To: Bill Start
From: David Zarozinski, Sanitarian
Date: September 11, 2001
Re: Alice Walas, 315 Potwine Lane, Amherst, septic system upgrade

DATE 5/16/95	JOB NO. 94-404
ATTENTION	
RE: DEP Transmittal 58599	
MANDLE PROP.	
POTWINE LA.	
AMHERST

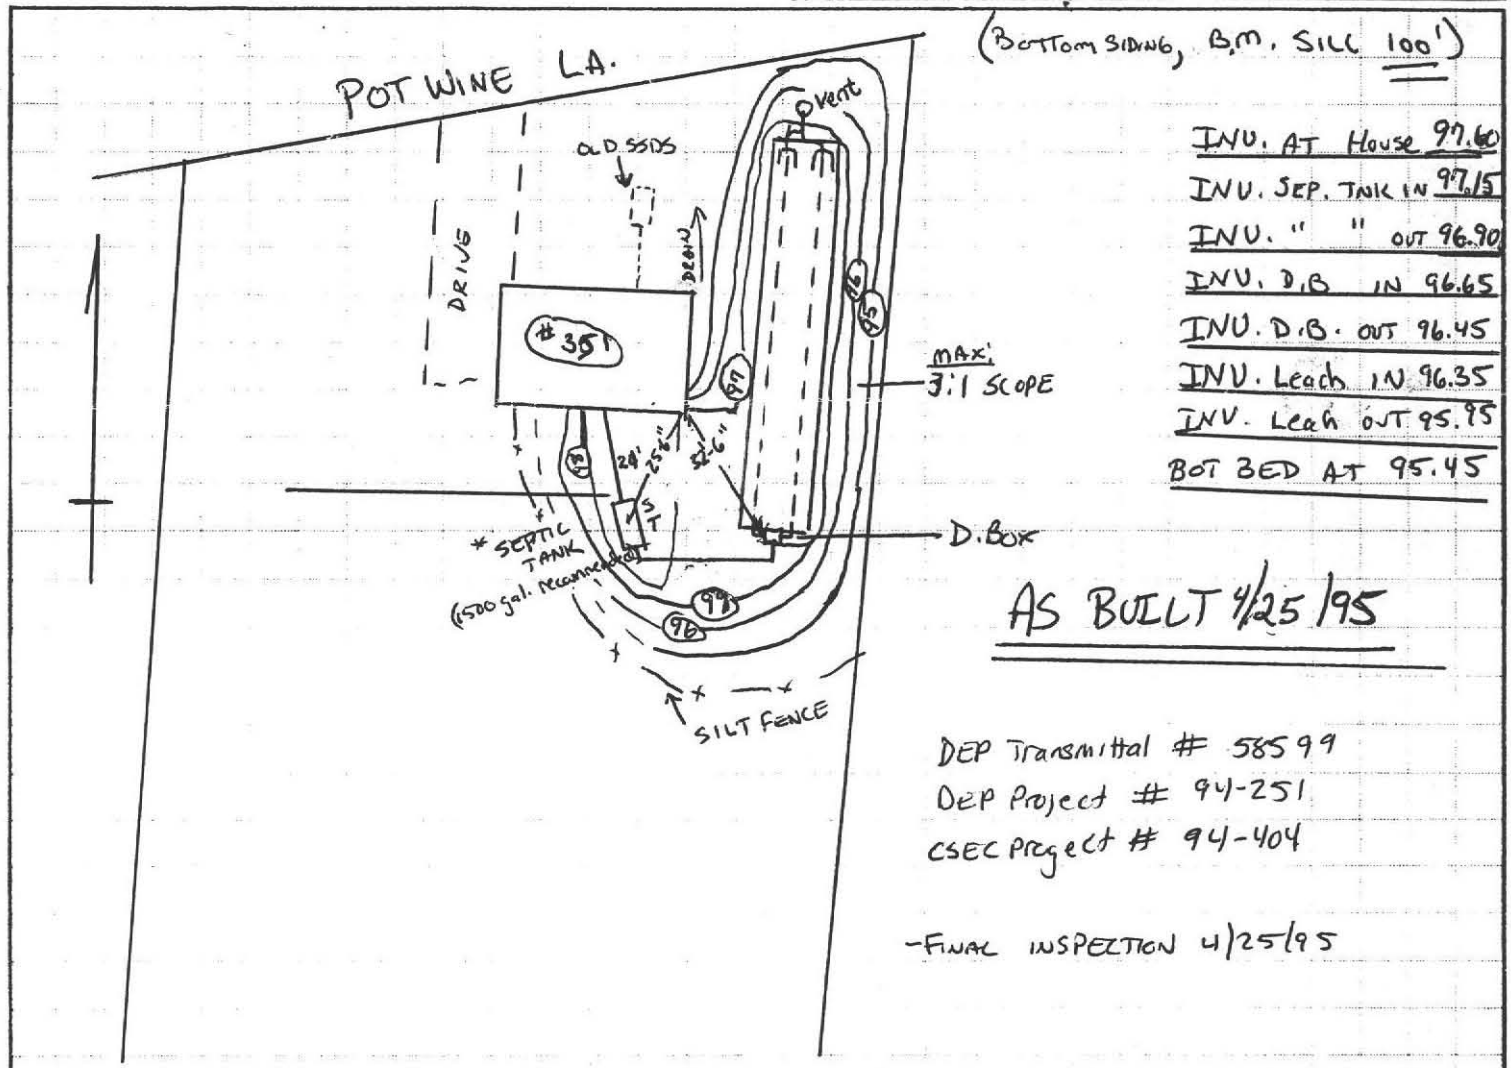
- NOTE: - WITH THIS CHANGE
- PLUMBING COST TO BE LOWER.
 - NO PUMP & CHAMBER NEEDED.
 - MORE FILL REQUIRED IN REAR OF HOUSE
 - MUST ENCLOSE WORK AREA W/ SILT FENCE.
 - BED ELEVATION + LOCATION IS SAME. AS APPROVED.
 - BED PITCH IS TO NORTH.
 - MULCH + SEED AT COMPLETION.

NOTE: PLUMBING AT REAR W/O PUMP COMPLETED AT RECOMMENDATION OF INSTALLER IN ORDER TO ACHIEVE GRAVITY FLOW AND MINIMIZE BASEMENT PLUMBING + CARPENTRY (FINISHED BASEMENT).
